CITY OF ALBUQUERQUE

RE: Westgate Heights Park Addition, Unit 2 (File: M09D008B)
8810 Sonya Ave. SW
Grading Plan and Drainage Plan
Engineer's Stamp Date – 12/010/2015

Based upon the information provided in your submittal received 12-10-15, the above referenced Grading Plan and Drainage Plan cannot be approved for Grading Permit and Paving Permit until the following comments are addressed.

DRAINAGE AND GRADING PLAN 1 OF 2

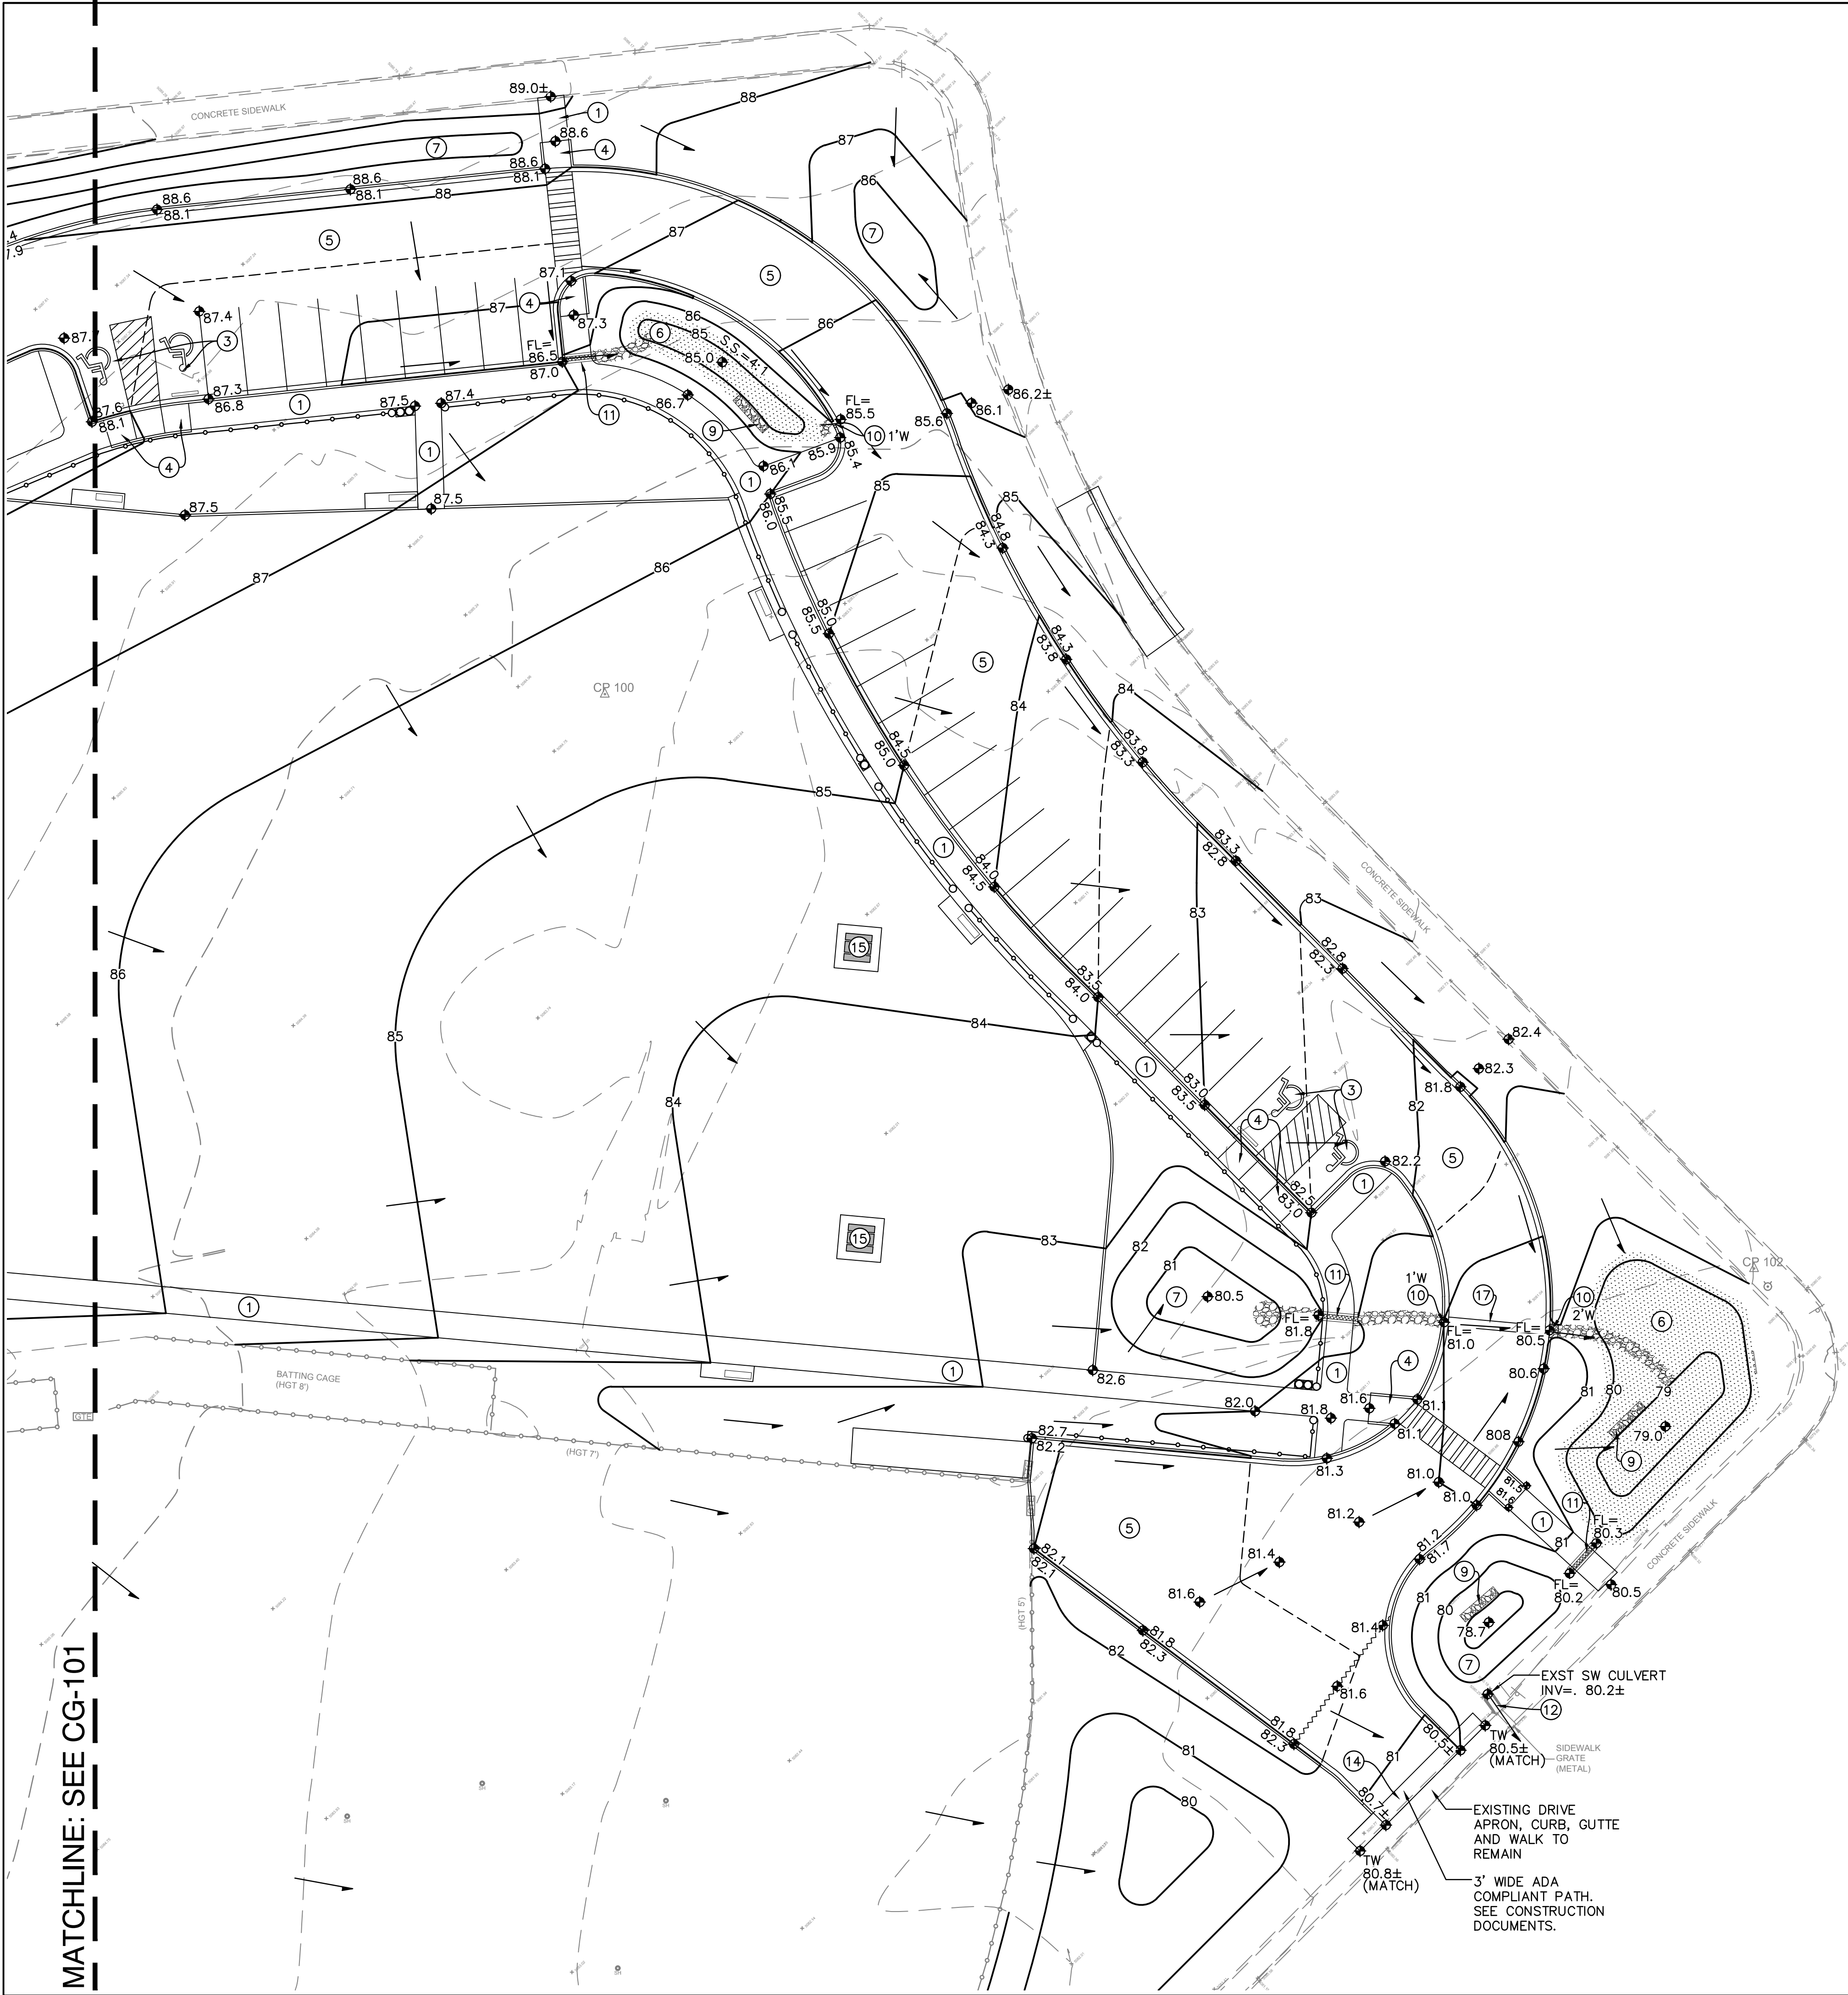
- Provide spot and contour elevations on the Overall Grading and Drainage Plan sheet.
- Provide flow line elevations at the outfall for each proposed sidewalk culvert onsite.
- The total area for historic flows does not match the total area for developed flows in the Calculation section of the Overall Grading and Drainage Plan sheet. Review this information to ensure the total basin area for existing and proposed conditions match.
- The area of land treatment D used in the First Flush calculation shown appears to be based on information provided in the previous submittal. Update the First Flush calculation on the Grading General Notes and Details sheet to reflect the changes to the area of land treatment D shown in the Calculation section of the Overall Grading and Drainage Plan sheet.
